Access Compliance Report

Public Rights-of-Way

Intersection ID: 15956	Main Street: POINDEXTER_DR	Cross Street: SEDGEFIELD_RD	Location: S
ADA ID: 0F912306F571	Ramp Type: PerpDiag	Initial Pass/Fail: Fail	Overall Compliance: No
		Severity Score: 1.25

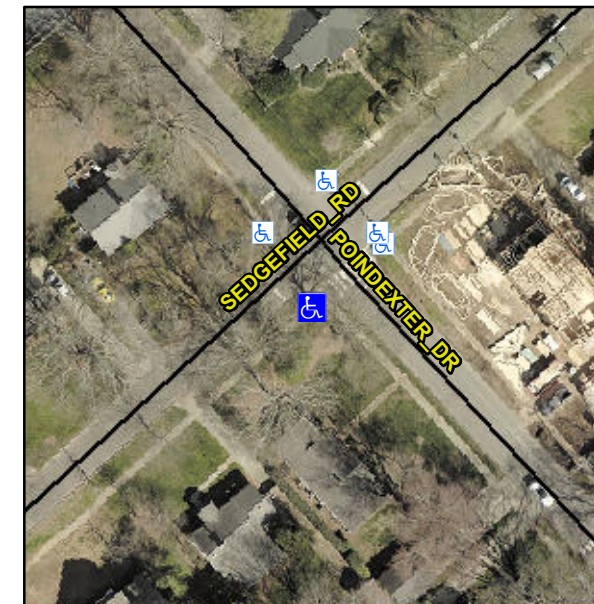
R304.5.3

Compliance	Description	Data	Compliance	Description	Data
N/A	Ramp Length (in)	83.0	Yes	Ramp Slope (%)	5.1
Yes	Ramp Width (in)	48.0	No	Ramp XSlope (%)	2.2
N/A	Flare Type LT	N/A	N/A	Flare Type RT	N/A
N/A	Flare Slope LT (%)	N/A	N/A	Flare Slope RT (%)	N/A
N/A	Flare Traversable LT?	N/A	N/A	Flare Traversable RT?	N/A
N/A	Landing Length (in)	N/A	N/A	DWS Provided?	N/A
N/A	Landing Width (in)	N/A	N/A	DWS Contrast?	N/A
N/A	Landing Slope (%)	N/A	N/A	DWS Length (in)	N/A
N/A	Landing X Slope (%)	N/A	N/A	DWS Full Width?	N/A
N/A	Landing Curb? (Y/N)	N/A	N/A	DWS Offset (in)	N/A
N/A	Shared Landing?	N/A			
N/A	Gutter Ponding?	N/A	N/A	Gutter Slope (%)	N/A
N/A	Gutter Lip Ht (in)	N/A	N/A	Gutter X Slope (%)	N/A
N/A	Painted X Walk1?	Yes	N/A	Painted X Walk2?	No
	X Walk 1 Direction	To NE		X Walk 2 Direction	To NW
N/A	X Walk 1 Width (in)	113.0	N/A	X Walk 2 Width (in)	N/A
	X Walk 1 Slope (%)	3.3		X Walk 2 Slope (%)	2.9
	X Walk 1 X Slope (%)	2.8		X Walk 2 X Slope (%)	0.6

Remove & Replace Curb Ramp With Two New Directional Ramps or Equivalent.
